COMERICA BANK AT WESTMARKET SQUARE SP 07-57

COMERICA BANK AT WESTMARKET SQUARE, SITE PLAN NUMBER 07-57

PLANNING REVIEW

January 25, 2008

Wall Length

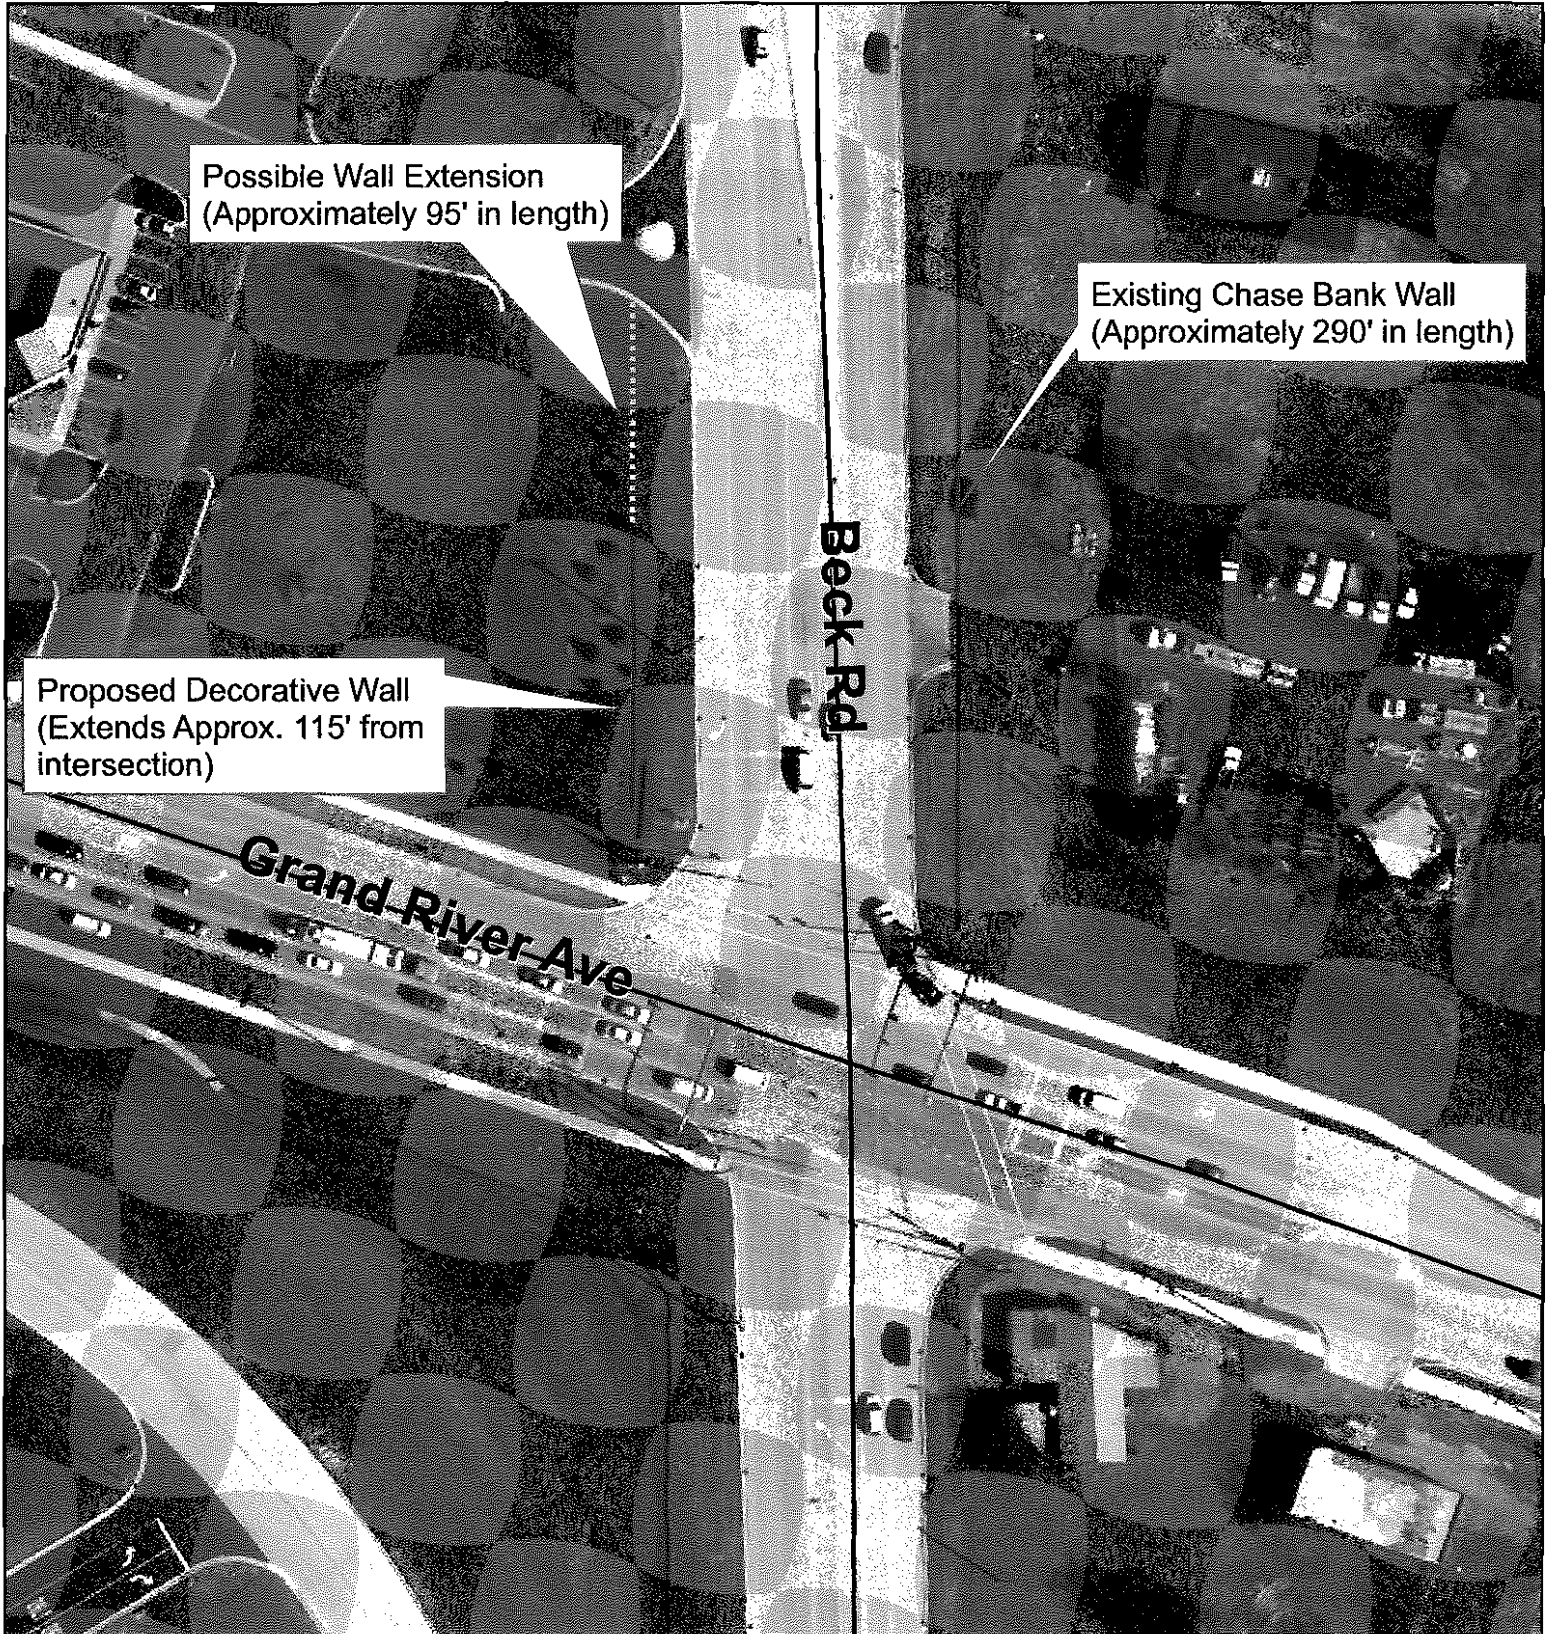
1. Provide a 205'-long decorative wall along the entire Beck Road frontage, matching the wall on the Chase Bank site across Beck Road. (A Planning Commission waiver from the berm standard would be required to provide the wall);

Possible Wall Extension
(Approximately 95' in length)

The wall, as shown, matches the length that was to be provided by the West Market Fuel approved site plan. The design materials will match the wall built on the Chase Bank site on the opposite side of Beck Road. It is the owner's desire to provide the wall to limits as shown on the plan and continue with a 3' high berm that is required by the ordinance.
